Subject: MHI's Responses to US-APWR DCD RAI No. 362-2278

Reference: [1] "Request for Additional Information No. 362-2278 Revision 0, SRP Section: 09.02.02 – REACOR AUXILIARY COOLING WATER SYSTEM – Design Certification and New License Applicants, Application Section: 9.2.2," dated May 13, 2009.

Responses to Request for Additional Information
No. 362-2278 Revision 0

RAI NO.: NO. 362-2278 REVISION 0
SRP SECTION: 09.02.02 – REACTOR AUXILIARY COOLING WATER SYSTEM
APPLICATION SECTION: 9.2.2
DATE OF RAI ISSUE: 5/13/2009

Figure 2.7.3.3-1 Component Cooling Water System (Sheet 1 of 2)

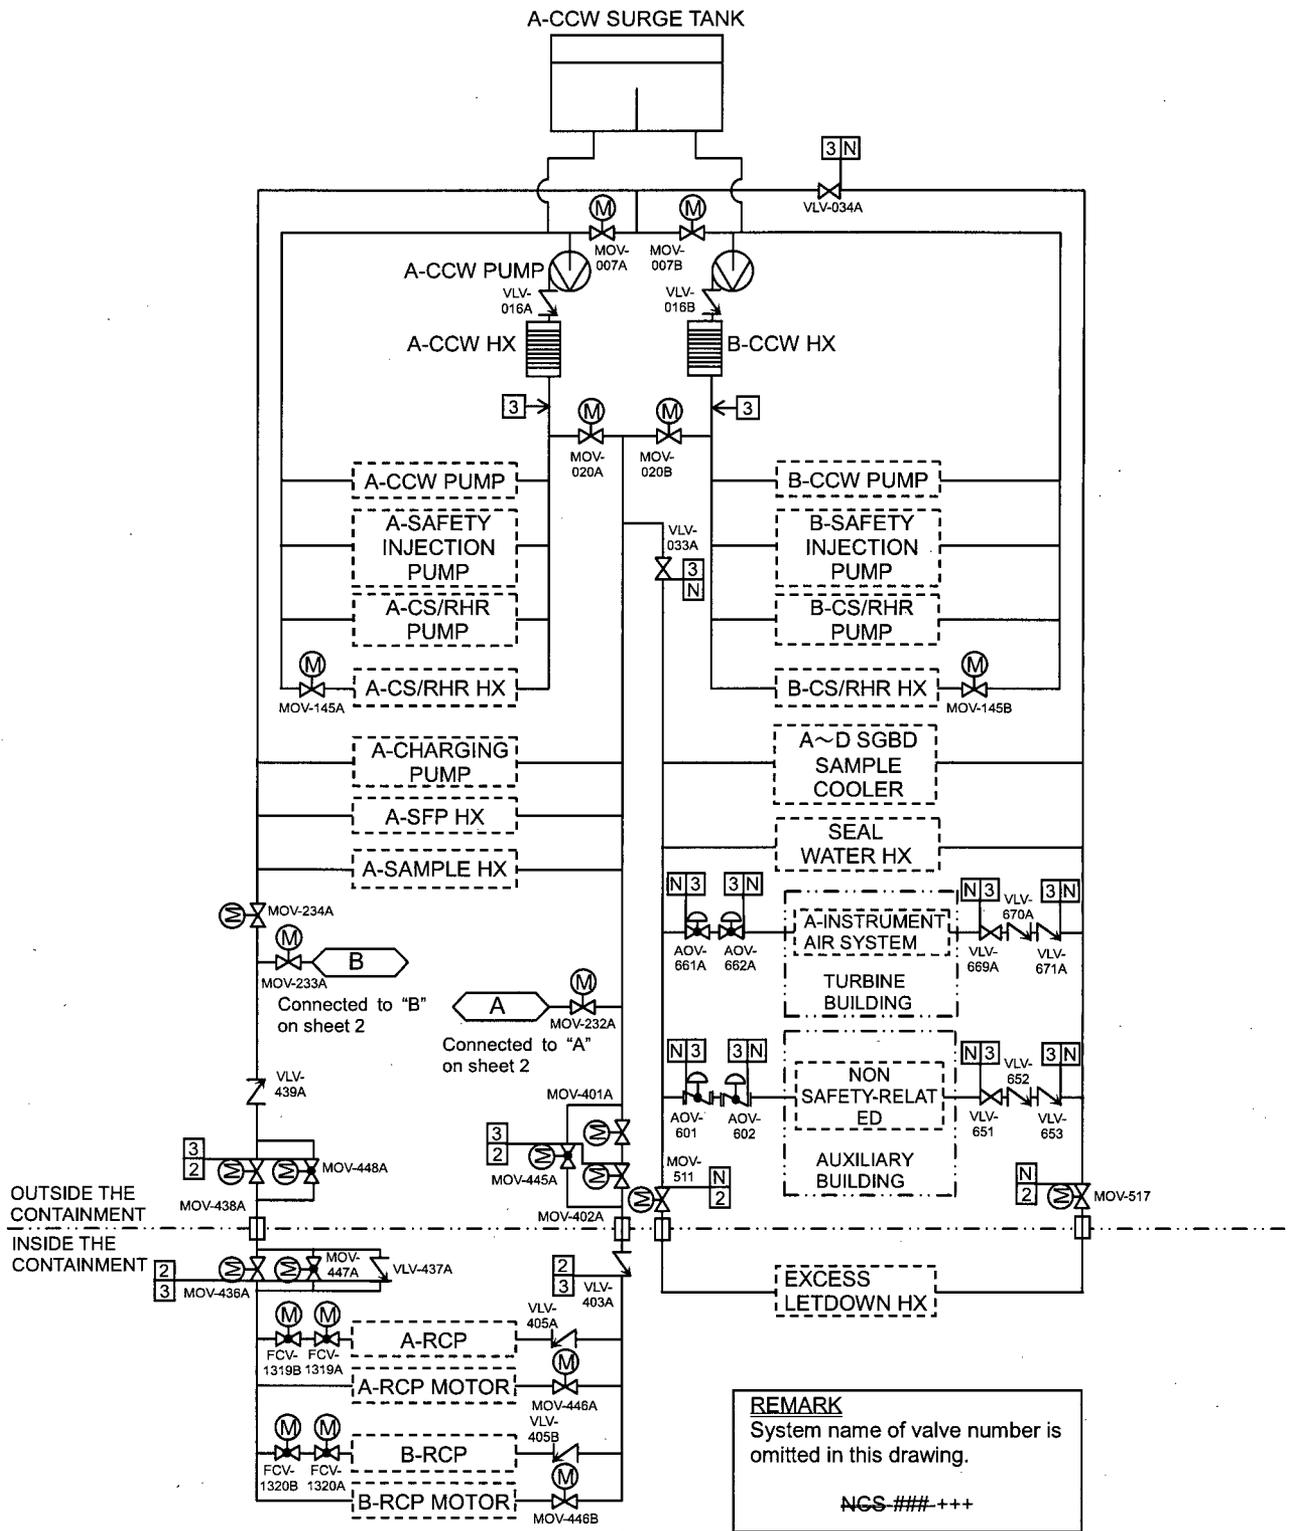
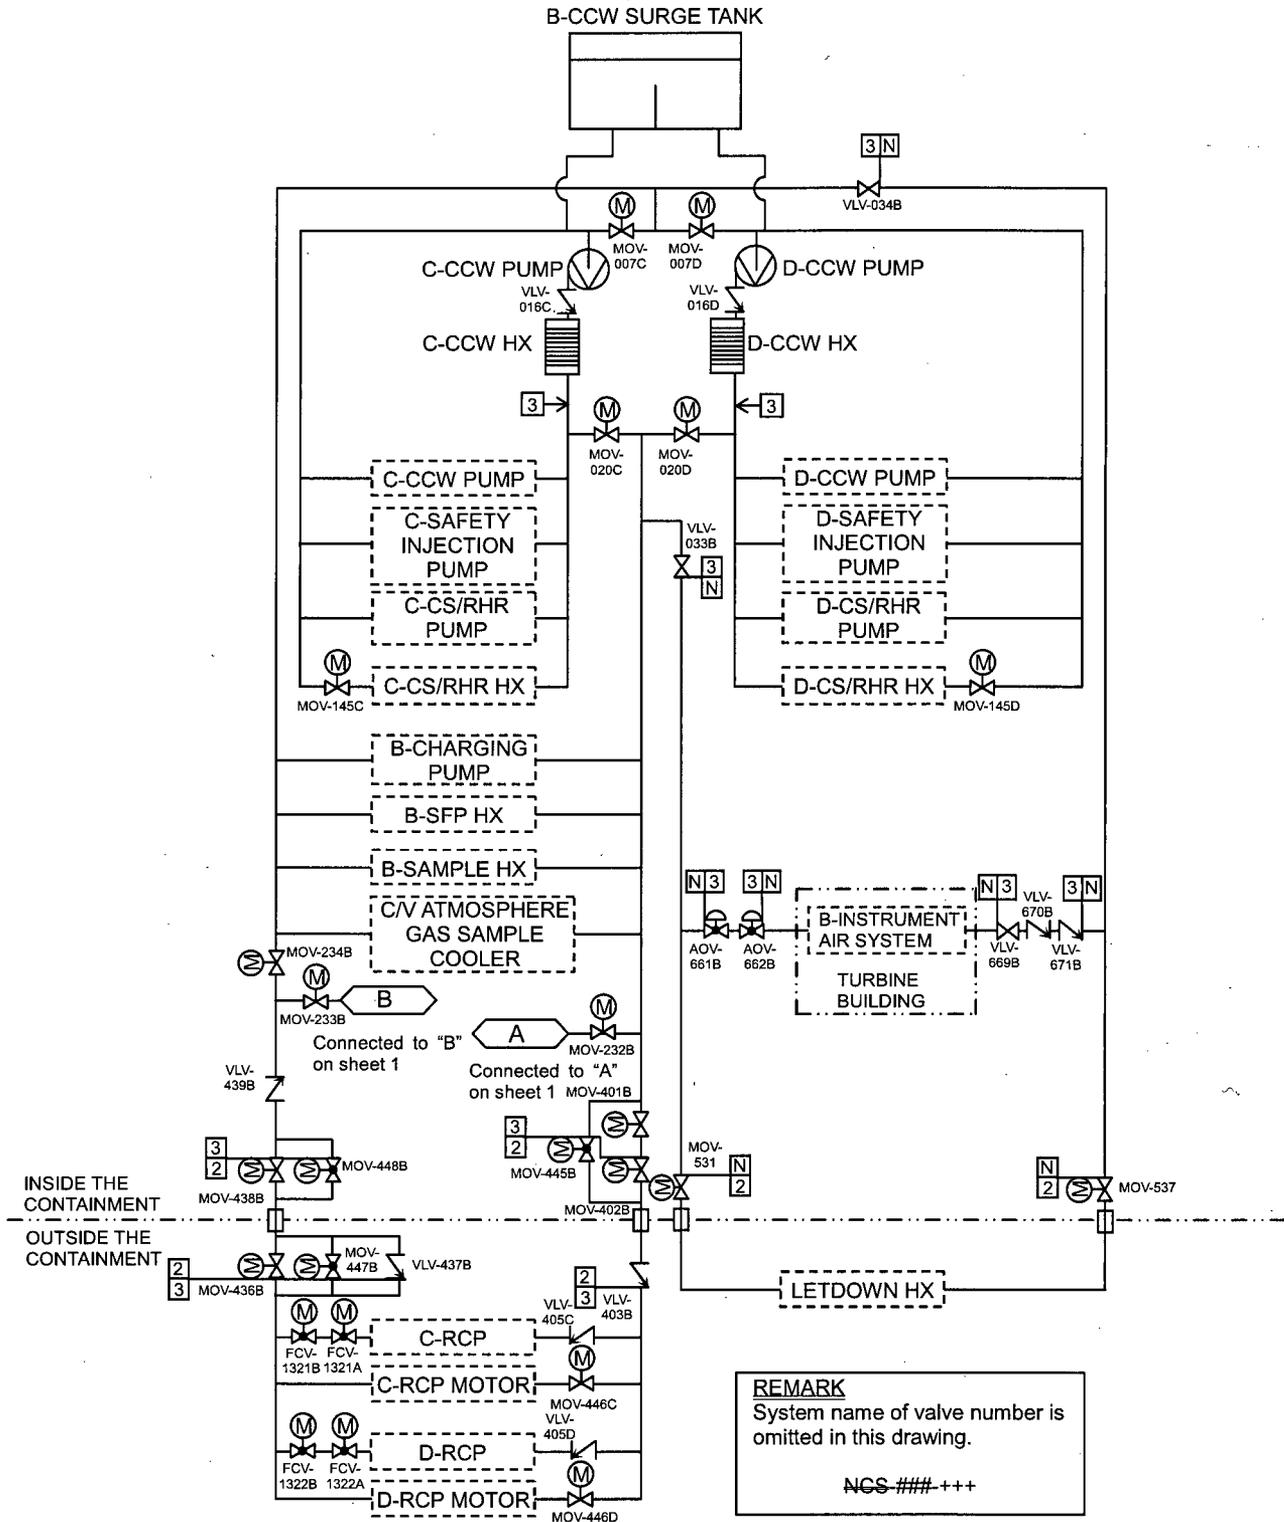
Check valve functionality needs to be added to Table 2.7.3.3-5.

The check valves with safety-related function addressed in DCD Tier 2 Table 3.9-14 on "Valve Inservice Test Requirements" will be added to the Tier 1 figure. These valves are also added to Table 2.7.3.3-2 and Table 2.7.3.3-5 as ITAAC confirmation items.

- DCD Tier 1 Figure 2.7.3.3-1 will be revised as shown below:
